Project	IEEE 802.16 Broadband Wireless Access Working Group < http://ieee802.org/16 >
Title	A Four Symbol Pilot Format for Improved Support for TDM Multiplexing of 16m with WirelessMAN-OFDMA. (Sections 16.3.5 – DL PHY Structure – Pilot Structure)
Date Submitted	2009-12-31
Source(s)	Fred Vook, Mark Cudak, Bill, Hillery, Eugene Visotsky, Anup Talukdar Motorola Inc. fred.vook@motorola.com
Re:	Category: P802.16m/D3 comments for LB30b Area: Sections 16.3.5.4 (DL PHY Structure – Pilot Structure)
Abstract	Multiplexing of Advanced Air Interface Frames with WirelessMAN-OFDMA currently requires a minimum of two 16m subframes in a DL frame. To enable a minimum of one 16m subframe on the DL, a four-symbol pilot format will be required if the six symbol subframe contains both a preamble and a MIMO midamble. This contribution proposes a four symbol pilot format for the purpose of providing better flexibility in multiplexing 16m with legacy WirelessMAN-OFDMA.

A Four Symbol Pilot Format for Improved Support for TDM Multiplexing of 16m Subframes with WirelessMAN-OFDMA. (Sections 16.3.5.4 – DL PHY Structure – Pilot Structure)

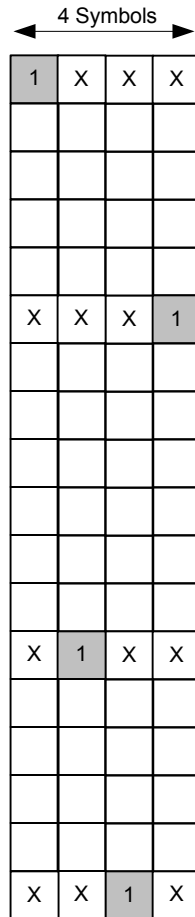
***[One and Two-Stream Pilot Formats - Section 16.3.5.4:
Modify the paragraph that starts on page 337, line 14]***

For the AAI subframe consisting of 5 symbols, the last OFDM symbol in each pilot pattern set shown in [Figure 485](#), [Figure 486](#), [Figure 489](#), [Figure 490](#) and [Figure 491](#) is deleted. For the AAI subframe consisting of 4 symbols, the last two OFDM symbols in each pilot pattern set shown in [Figure 485](#), [Figure 486](#), [Figure 489](#), [Figure 490](#) and [Figure 491](#) are deleted. For the AAI subframe consisting of 7 symbols, the first OFDM symbol in each pilot pattern set shown in [Figure 485](#), [Figure 486](#), [Figure 489](#), [Figure 490](#) and [Figure 491](#) is added as 7th symbol.

(d)

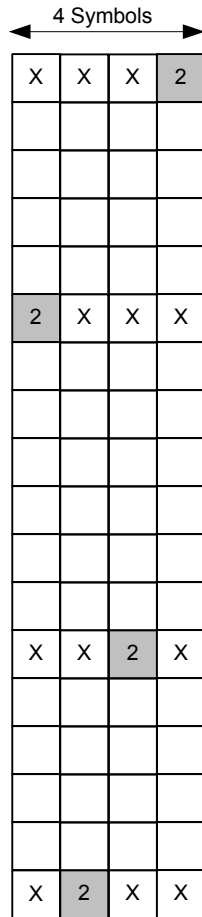
[Modify Figure 492 by adding the following graphic as “Subfigure” (d):

The pilot patterns on stream 0 - stream 3 for four pilot streams are shown in [Figure 492](#) through [Figure 495](#) respectively, with the subcarrier index increasing from top to bottom and the OFDM symbol index increasing from left to right. Subfigures (a) in [Figure 492](#) through [Figure 495](#) show the pilot pattern for four pilot streams in AAI subframe with six OFDM symbols; Subfigures (b) in [Figure 492](#) through [Figure 495](#) show the pilot pattern for four pilot streams in AAI subframe with five OFDM symbols; Subfigures (c) in [Figure 492](#) through [Figure 495](#) show the pilot pattern for four pilot streams in AAI subframe with seven OFDM symbols; Subfigures (d) in [Figure 492](#) through [Figure 495](#) show the pilot pattern for four pilot streams in AAI subframe with four OFDM symbols.

(d)

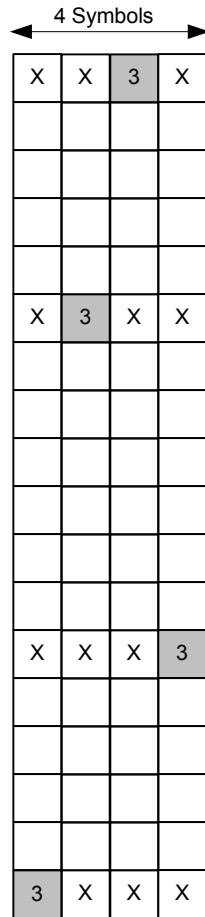
[Modify Figure 493 by adding the following graphic as “Subfigure” (d):
